## ADDENDUM NO. 1

HVAC Repairs, Blade & Paint Shop Building  
AVCRAD Army Aviation Site  
Springfield, Missouri  
PROJECT NO. T2329-01

**Bidders are hereby informed that the Construction Plans and/or Specifications are modified as follows:**

**M-100**  
2 OF 4 SHEETS  
07/12/2024

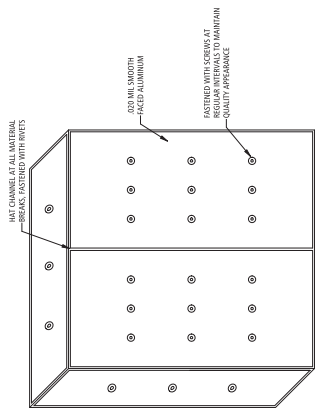
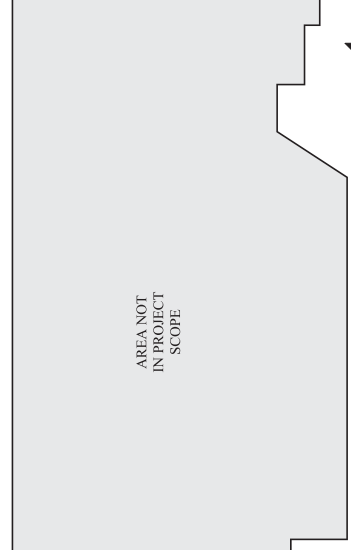
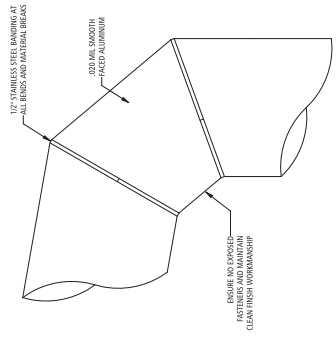
1. Sheet M-100
  - a. REMOVE and REPLACE with attached revised Sheet M-100.
2. Sheet M-101
  - a. REMOVE and REPLACE with attached revised Sheet M-101.
